PARK LANE MIXED USE

KIRKLAND, WA

## DESIGN REVIEW RESPONSE

"AFTER" PERSPECTIVE VIEWS

"AFTER" - CORNER OF PARK LANE AND MAIN STREET

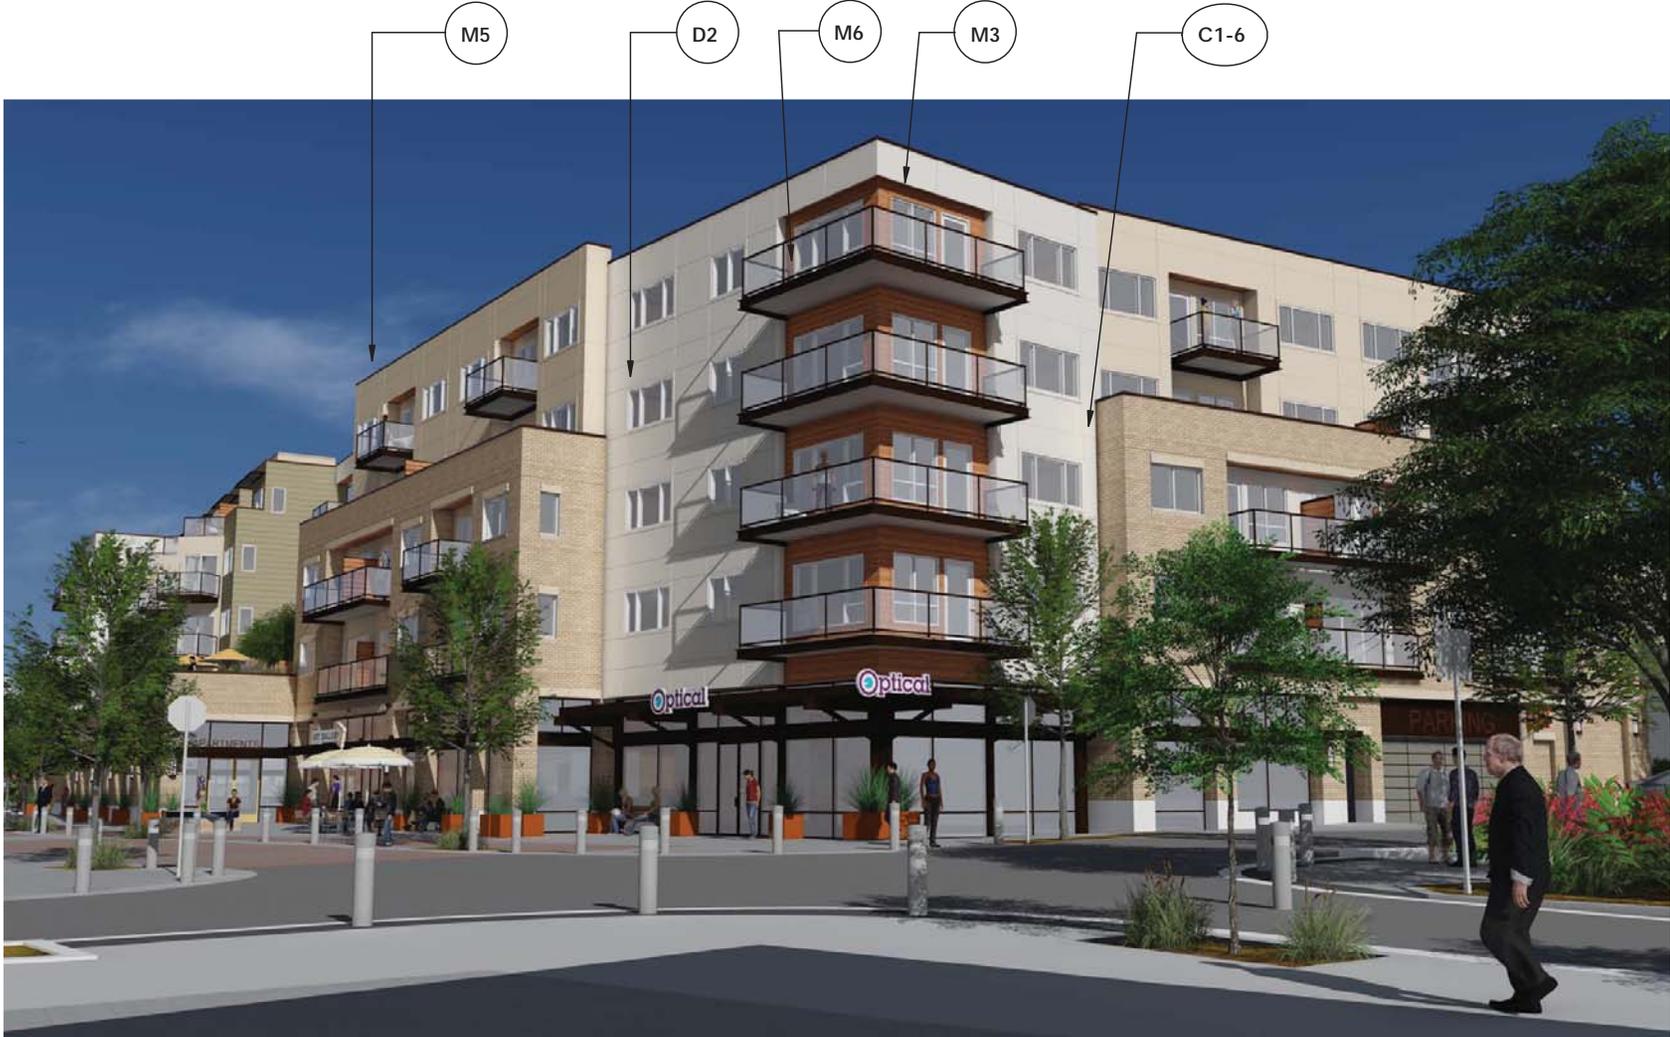
**M3:** SIGNIFICANT CORNERS ON MAIN & PARK LANE FEEL HEAVY. REVIEW MASSING AT CORNERS TO REDUCE VISUAL WEIGHT AND "FLAT" EXPANSES OF WALL.

**M5:** REVIEW HOW BUILDING MEETS THE SKY. SIMPLE CORNICE FLASHING SHOWN DOES NOT PROVIDE ENOUGH DETAIL, VARIETY OR INTEREST, ESPECIALLY FOR "MULTI-BUILDING" CONCEPT.

**M6:** MIXED OPINIONS ON CORNER BALCONIES. CONCERN EXPRESSED ABOUT VISUAL WEIGHT OF THIS DETAIL. REVIEW MASSING / DETAIL.

**D2:** REVIEW WINDOW SIZES FOR VARIETY & INTEREST AND TO REDUCE APPEARANCE OF "FLAT" WALLS.

REVISED COLOR & MATERIALS PALETTE PROVIDES MORE WARMTH, CONTRAST, COLOR & TEXTURE FOR VISUAL INTEREST & SCALE OF BUILDING.

**M3:** MASSING OF CORNER HAS BEEN REVISED TO PROVIDE MORE ARTICULATION. LARGE EXPANSES OF "FLAT" WALLS HAVE BEEN ELIMINATED THROUGH USE OF MATERIAL, COLOR AND TEXTURE ("WOODTONE" FIBER CEMENT LAPPED SIDING), LARGER WINDOW SIZES AND DARK ACCENT WINDOW TRIMS. CORNER MATERIAL HAS BEEN EXTENDED DOWN TO VISUALLY CONNECT WITH STREETSCAPE. SEE SHT. 31 FOR CORNER CANOPY DETAIL.

**M5:** ARTICULATION OF PARAPET HEIGHTS AND CORNICE DETAILING HAVE BEEN ADDED TO PROVIDE MORE INTEREST & VARIETY AS THE BUILDING MEETS THE SKY. STEEL FABRICATED "SUNSHADES" HAVE BEEN PROVIDED AT SELECT LOCATIONS TO ADD DEPTH & INTEREST WITHOUT ADDING "MASS" TO THE BUILDING.

**M6:** CORNER BALCONIES HAVE BEEN REDUCED IN DEPTH BY 12". DARK METAL COLOR HAS BEEN LIGHTENED TO SOFTEN MASSING.

**D2:** WINDOW SIZES HAVE BEEN INCREASED AT KEY LOCATIONS. DARK COLOR WINDOW TRIM HAS BEEN ADDED THROUGHOUT TO REDUCE THE APPEARANCE OF "FLAT" OF WALLS.

"BEFORE" - PARK LANE COMMERCIAL FRONTAGE

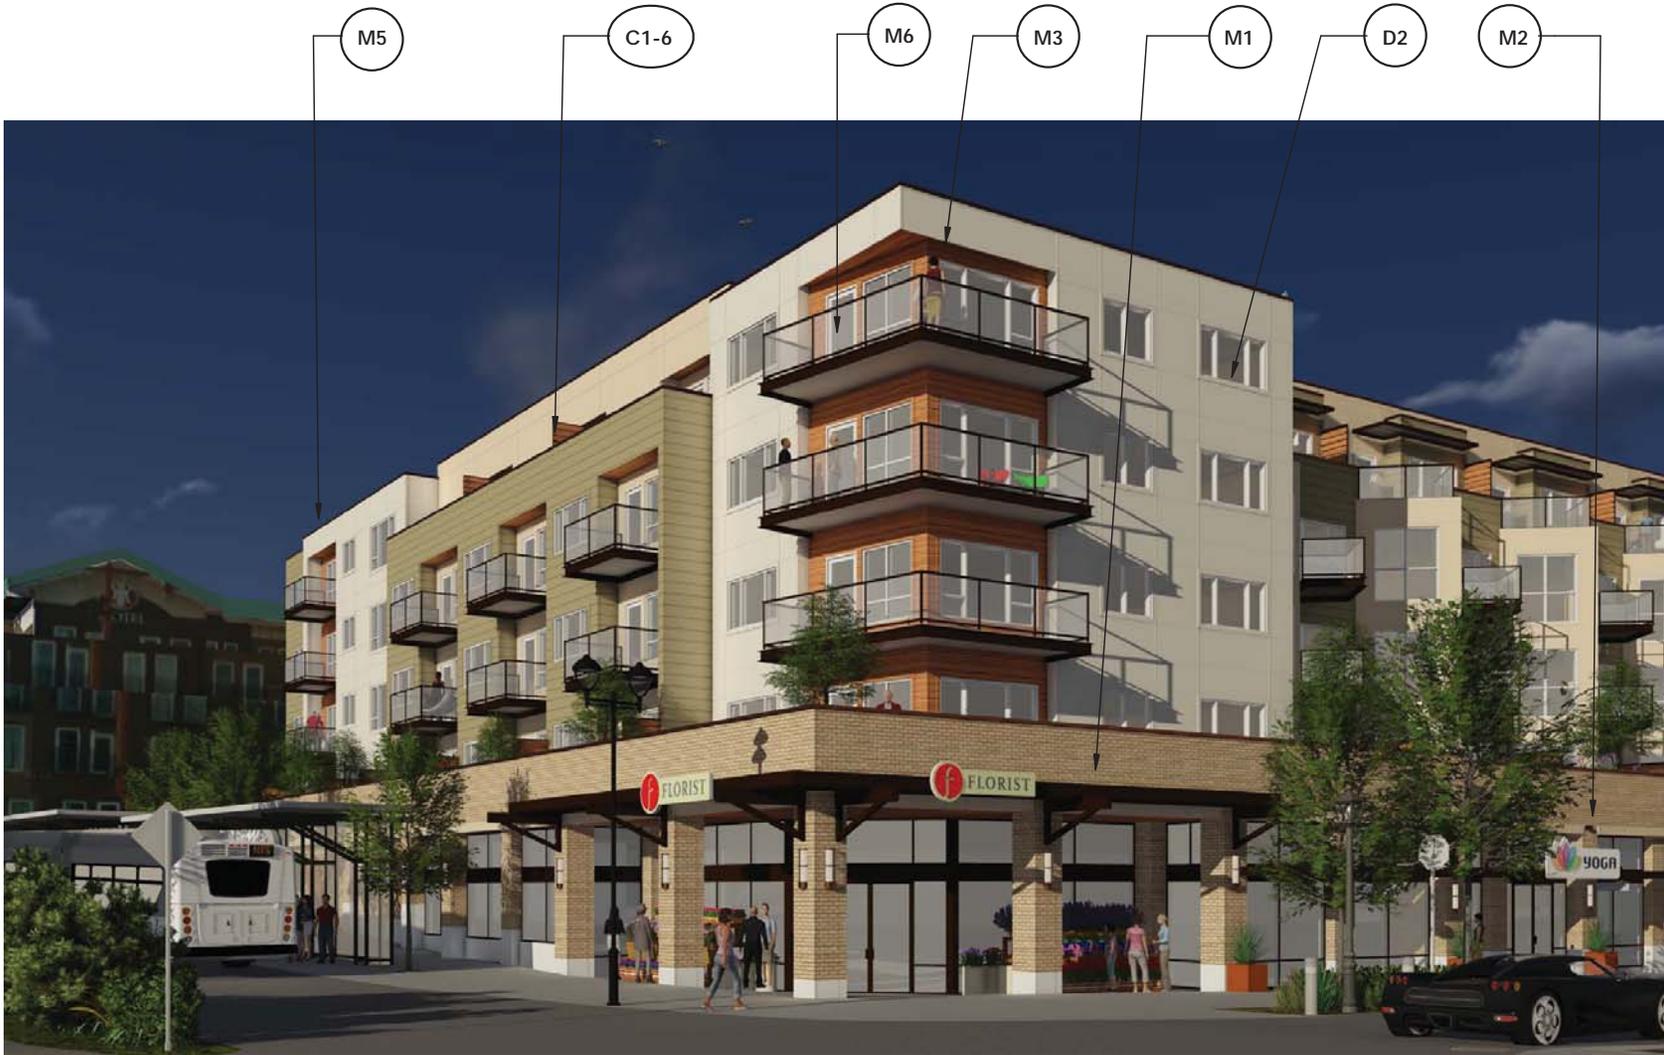
M2: PARK LANE COMMERCIAL FRONTAGE IS VERY LONG AND UNBROKEN. REVIEW DETAILING OF PARAPET WALL AND STOREFRONTS TO PROVIDE VARIETY & INTEREST. REMOVE ARCADE TO SHORTEN LENGTH OF WALL.

C1-6: REVISED BRICK COLOR PALETTE & DETAILING ADDS WARMTH, TEXTURE AND SCALE TO STREETScape.

"WOODTONE" FIBER CEMENT LAPPED SIDING AT CORNER EXTENDS DOWN TO ENGAGE STREETScape AND PROVIDES RICHNESS AND WARMTH.

M2: THE ARCADE HAS BEEN REMOVED TO REDUCE THE VISUAL WEIGHT OF THE CORNER AND TO SHORTEN THE LENGTH OF THE PARAPET WALL ALONG THE PARK LANE FRONTAGE. IN PLACE OF THE COVERED ARCADE, A CANOPY STRUCTURE HAS BEEN PROVIDED FOR COVERED PEDESTRIAN WEATHER PROTECTION AND SCALE. SEE SHEET 31 FOR ADDITIONAL DETAIL.

VARIATION IN CANOPY HEIGHTS & SUPPORT, SOFFIT MATERIAL, SIGNAGE AND SITE FURNISHINGS WILL PROVIDE PEDESTRIAN INTEREST ALONG THE COMMERCIAL STREETScape.

"AFTER" - 3RD STREET FRONTAGE (VIEWED FROM LIBRARY)

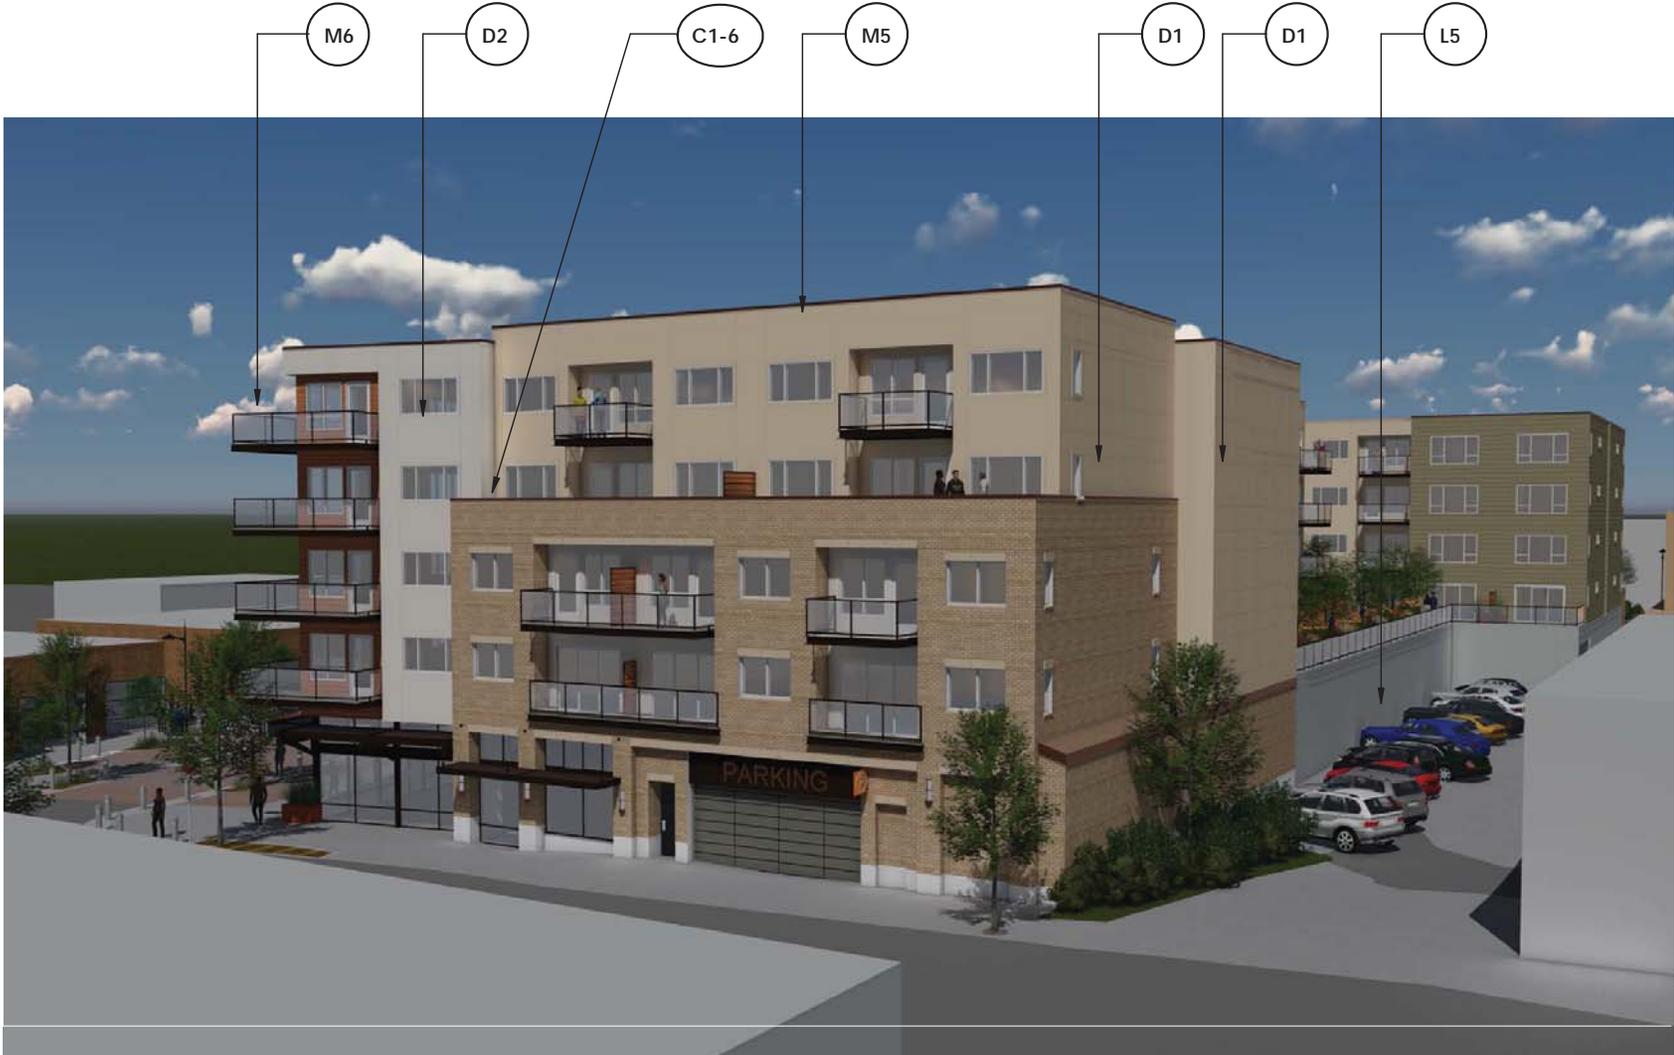
**M2:** REVIEW DETAILING OF PARAPET WALL TO PROVIDE VARIETY & INTEREST. REMOVE ARCADE TO SHORTEN LENGTH OF WALL.

**M5:** REVIEW HOW BUILDING MEETS THE SKY. SIMPLE CORNICE FLASHING SHOWN DOES NOT PROVIDE ENOUGH DETAIL, VARIETY OR INTEREST, ESPECIALLY FOR "MULTI-BUILDING" CONCEPT.

**M6:** MIXED OPINIONS ON CORNER BALCONIES. CONCERN EXPRESSED ABOUT VISUAL WEIGHT OF THIS DETAIL. REVIEW MASSING / DETAIL.

**D1:** BLANK WALLS ON SOUTH ELEVATION (ALLEY). MAXIMIZE THE AREAS WHERE THERE CAN BE WINDOWS. INCREASE NUMBER OF WINDOWS &/OR SIZE OF WINDOWS.

**D2:** REVIEW WINDOW SIZES FOR VARIETY & INTEREST AND TO REDUCE APPEARANCE OF "FLAT" WALLS.

**L2:** AREA BEHIND BUS SHELTER IS PROPOSED TO HAVE PUBLIC ART. WOULD LIKE TO SEE MORE LANDSCAPING & "LIFE" HERE INSTEAD. REVIEW HOW TO ADD LANDSCAPING ALONG THIS EDGE.

**C1-C6:** DEEP BLUE LAPPED SIDING PROVIDES ACCENT COLOR AND CONTRAST TO NATURAL CREAMS, TANS & "WOODTONE" AND IS COMPLIMENTARY TO THE BROWNS & GOLDEN COLOR OF ADJACENT HOTEL & LIBRARY.

**M2:** PARAPET WALL HAS BEEN SHORTENED WITH REMOVAL OF ARCADE. BRICK DETAILING HAS BEEN ADDED. SEE SHT. 34

**M5:** ARTICULATION OF PARAPET HEIGHTS AND CORNICE DETAILING HAVE BEEN ADDED TO PROVIDE MORE INTEREST & VARIETY AS THE BUILDING MEETS THE SKY. SEE SHT. 36 & 37 FOR DETAIL. STEEL FABRICATED "SUNSHADES" HAVE BEEN PROVIDED AT SELECT LOCATIONS TO ADD DEPTH & INTEREST WITHOUT ADDING "MASS" TO THE BUILDING.

**M6:** CORNER BALCONIES HAVE BEEN REDUCED IN DEPTH BY 12". DARK METAL COLOR HAS BEEN LIGHTENED TO SOFTEN MASSING.

**D1:** WINDOWS HAVE BEEN ADDED TO END UNITS AT ALLEY. HORIZONTAL TRANSITION OF SIDING MATERIAL FURTHER HELPS TO REDUCE SCALE OF BLANK WALLS.

**D2:** WINDOW SIZES HAVE BEEN INCREASED AT KEY LOCATIONS. DARK COLOR WINDOW TRIM HAS BEEN ADDED THROUGHOUT TO REDUCE THE "FLATNESS" OF WALLS.

**L2:** RECESSED HAVE BEEN CREATED TO ALLOW FOR THE ADDITION OF LANDSCAPING MATERIALS ON 3RD. - SEE SHT. 34 FOR DETAIL.

**PEDESTRIAN PLAZA**

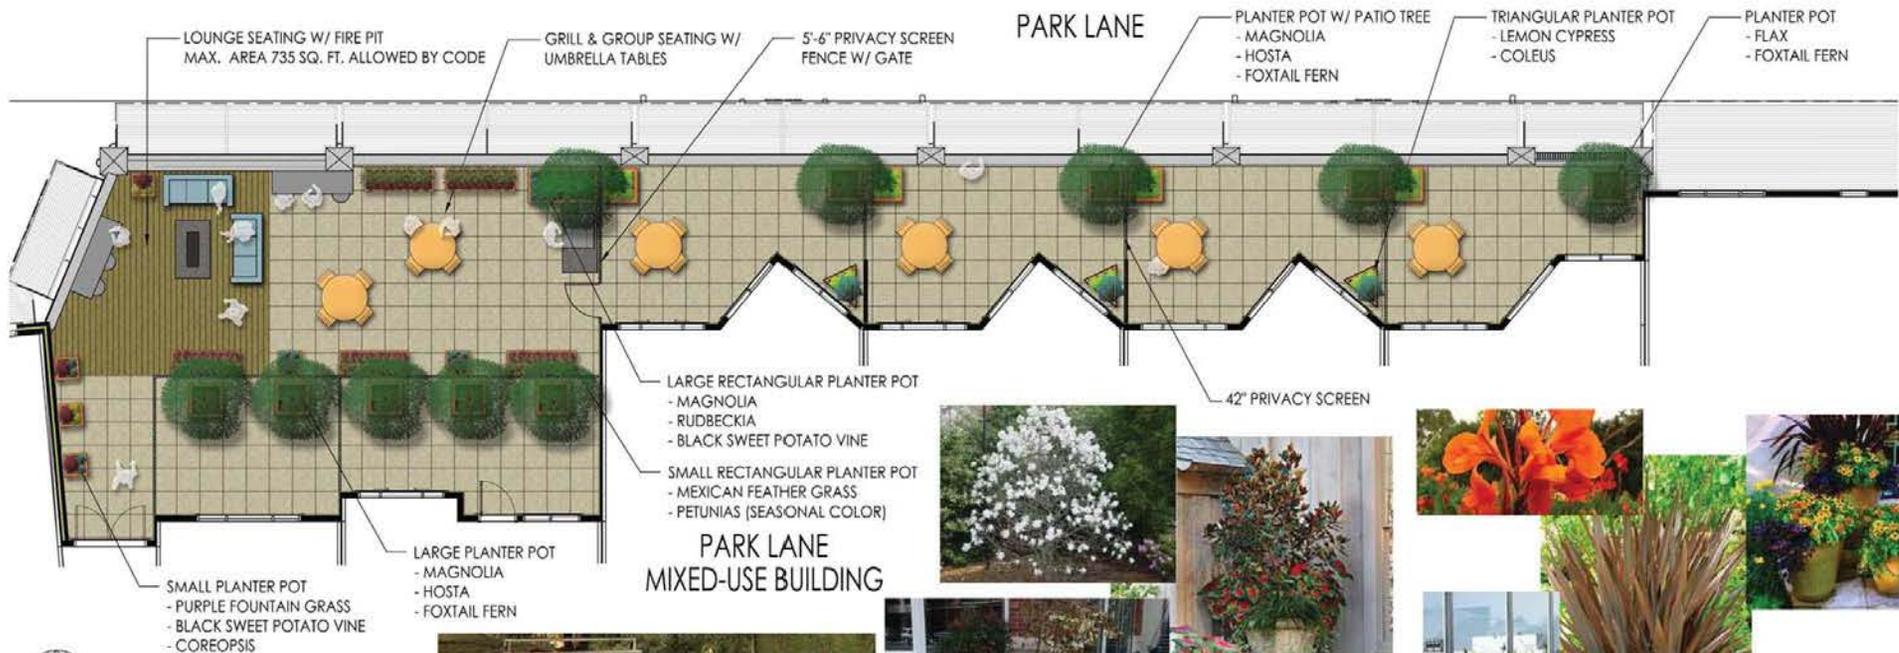
**Comment #1:** "Likes the podium-level patios - bring that warmth to the main floor/plaza".

**Comment #2:** "(Apartment) lobby entrance is still flat and is a stop to the courtyard. Either address it with landscaping or do something....."

**Comment #5:** General concern over the lack of landscaping and lack of interest in plant selections.

1. Extended pavers (and color) into the Plaza;
2. Added more and larger (free-standing) planters;
3. Incorporated larger pots for more extensive landscaping;
4. Added small trees and increased the number of evergreens;
5. Incorporated built-in concrete planters in Plaza;
6. Benches and umbrella tables.

1. Extended pavers (and color) into the Plaza;
2. Incorporated larger pots and built-in concrete planters;
3. Added a built-in planter at the water feature;

1. Added larger, free-standing pots and built-in planters in main (NW) Plaza;
2. Added pots and benches at NE Plaza;
3. Added small trees and increased the number of evergreens;

### SECOND LEVEL - SOUTH TERRACE

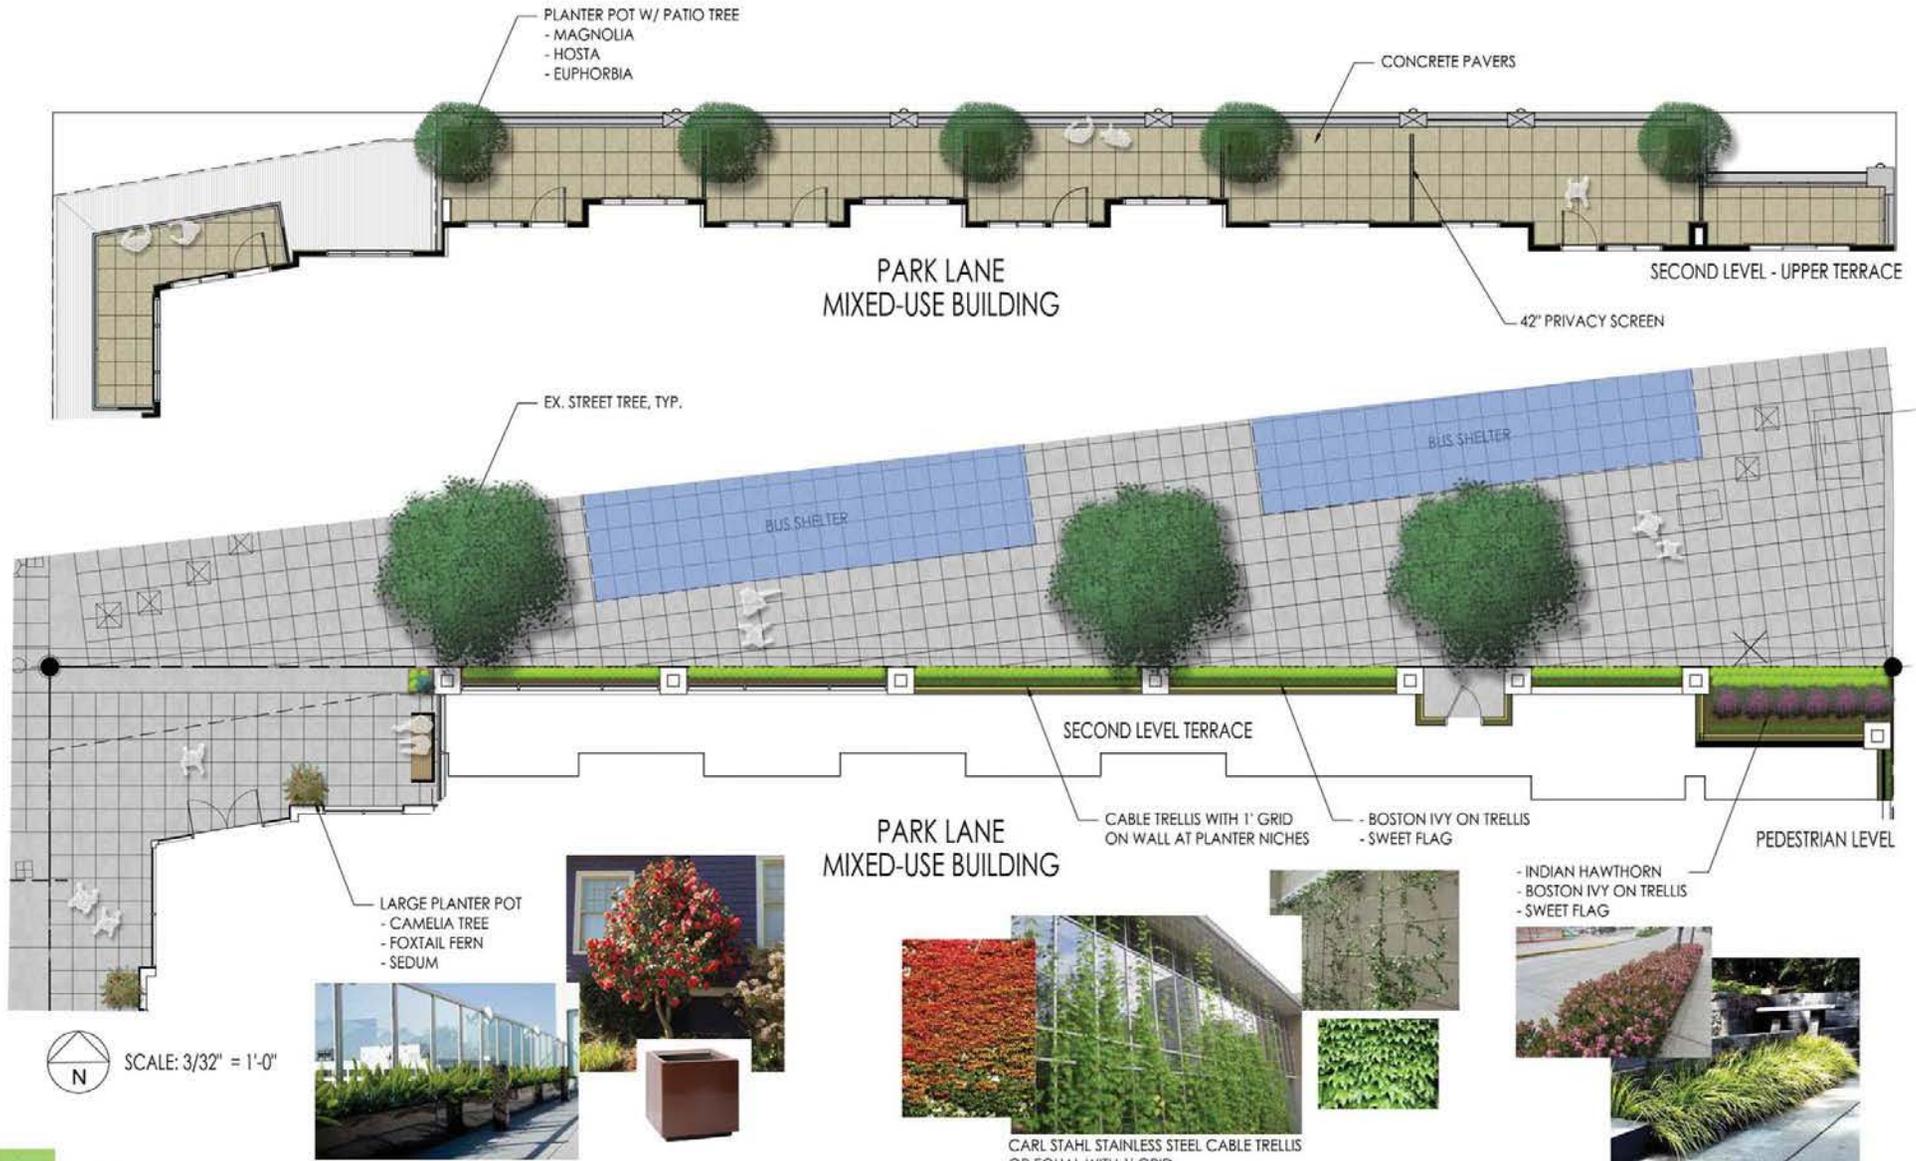
**Comment #4:** "Some areas can't be seen, but simple things like Boston Ivy trailing over the huge wall....."

1. South terrace - moved railing to the north - added planter at top of wall with spilling/trailing vines;
